MIAMI-DADE COUNTY DEPARTMENT OF TRANSPORTATION AND PUBLIC WORKS (DTPW)

ADDENDUM NO. 1 December 30, 2024

PROJECT: Metrorail Bathroom Rehabilitation

RPQ No: TP-0000027284

SHEET A101

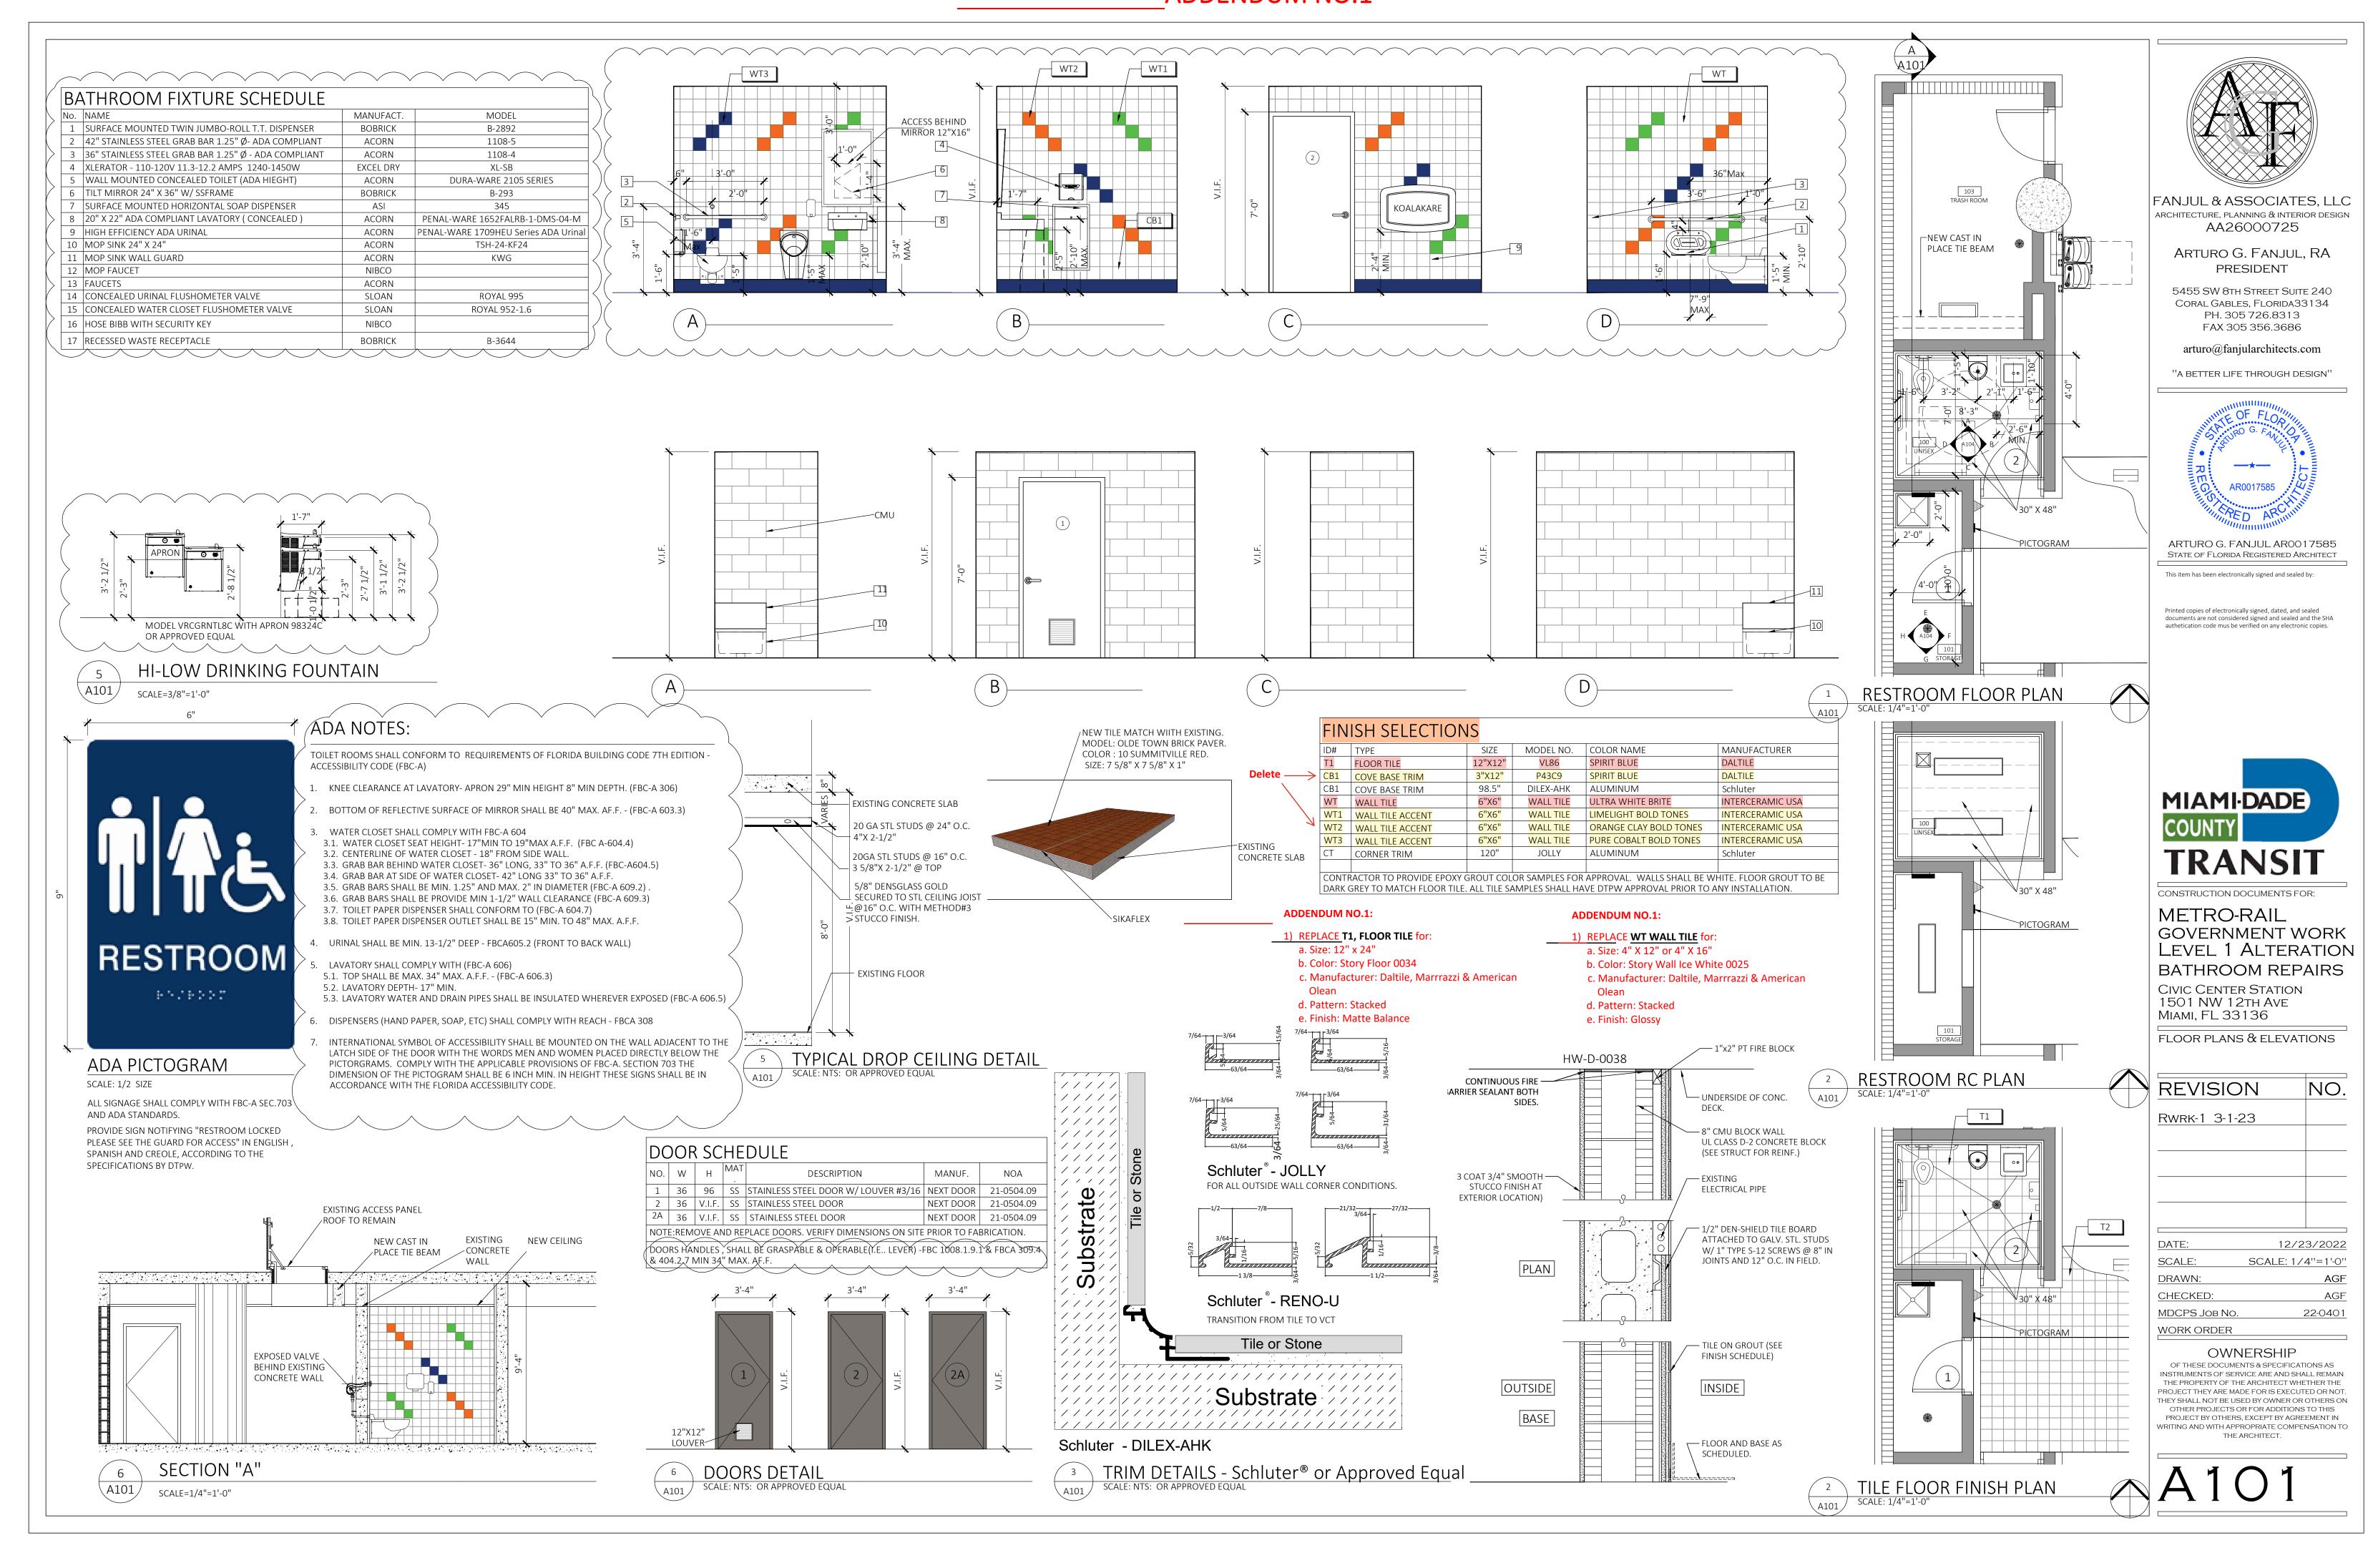
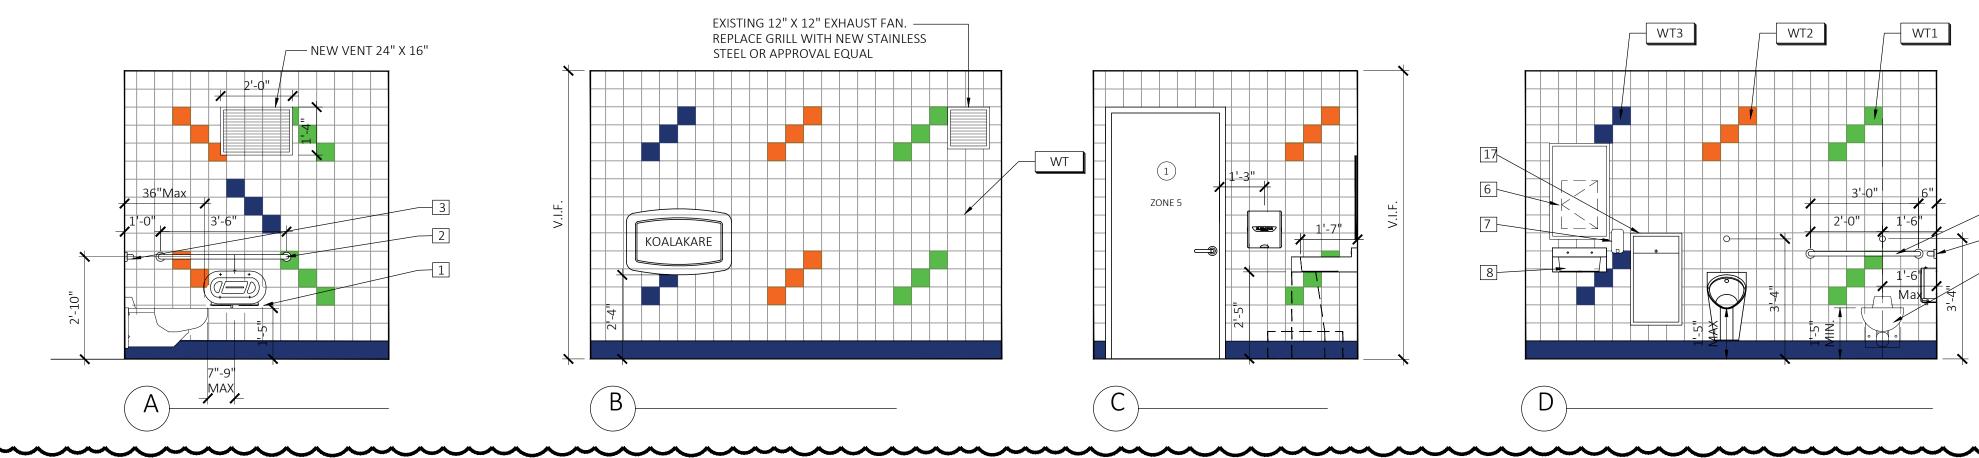
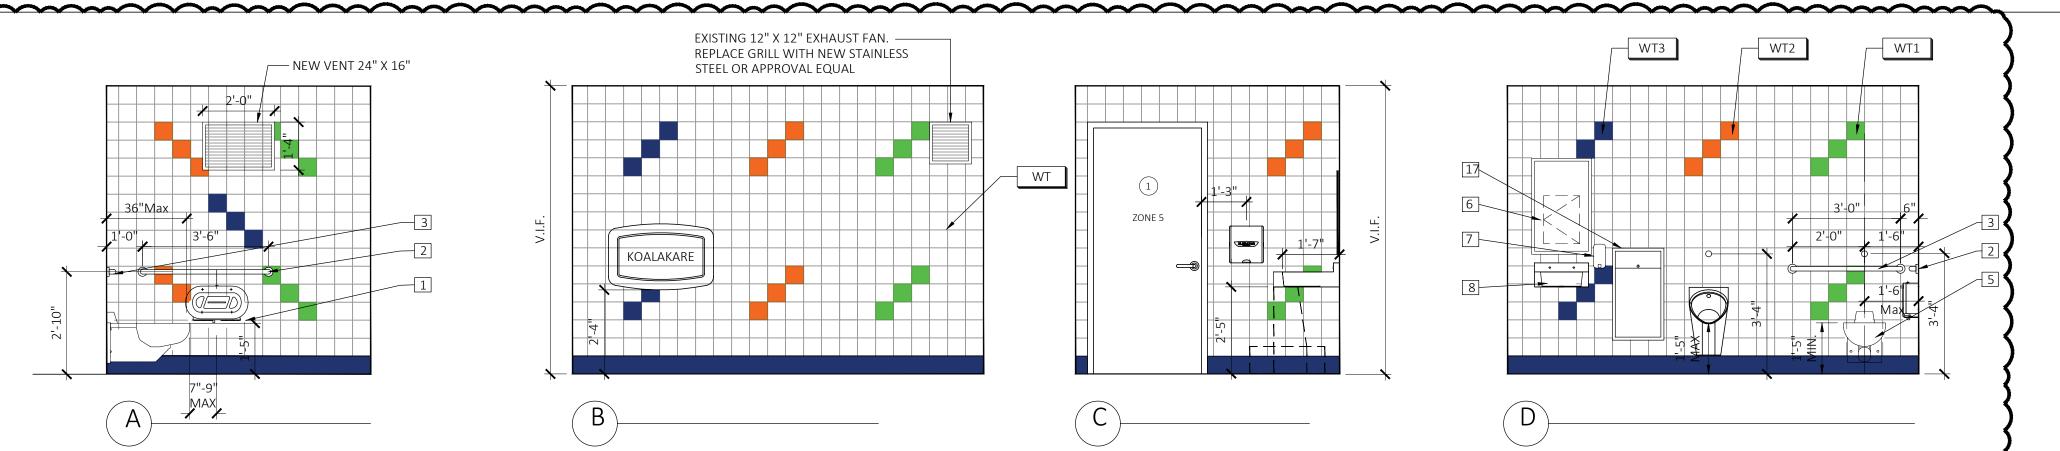
- 1. Sheet A101, all three (3) sets of Engineering Drawings. "Finish Selection Table"; the following information will change as such: (See attached documents below)
 - a. ID# T1, Type: Floor Tile: will be replaced with:
 - i. Size: 12" x 24"
 - ii. Color: Story Floor 0034
 - iii. Manufacturer: Daltile, Marrazzi & American Olean
 - iv. Pattern: Stacked
 - v. Finish: Matte Balance
 - b. ID# WT, Type: Wall Tile: will be replaced with:
 - i. Size: 4" x 12" or 4" x 16"
 - ii. Color: Story Wall Ice White 0025
 - iii. Manufacturer: Daltile, Marrazzi & American Olean
 - iv. Pattern: Stacked
 - v. Finish: Glossy
 - c. ID#CB1, Type: Cove Base Trim: will be omitted.
 - i. Size: 3" x 12"
 - ii. Model No.: P43C9
 - iii. Color Name: Spirit Blue
 - iv. Manufacturer: Daltile

- d. ID# WT1, WT2, & WT3, Type: Wall Tile Accent: will be omitted:
 - i. Size: 6" x 6"
 - ii. Color: Limelight bold, Orange Clay Bold, and Pure Cobalt Bold.
 - iii. Manufacturer: Interceramic USA.
 - iv. Model No.: Wall Tile.
- 2. All three (3) sets of Engineering Drawings. "Any reference to grout"; shall be deleted and replaced with the following:
 - a. <u>Floor Tile Grout:</u> Epoxy Integral color grout. Laticrete epoxy grout. Grout Color: 78 Steeling Silver.
 - b. Wall Tile Grout: Epoxy Integral color grout. Laticrete Epoxy Grout. Color: 44 Bright White.
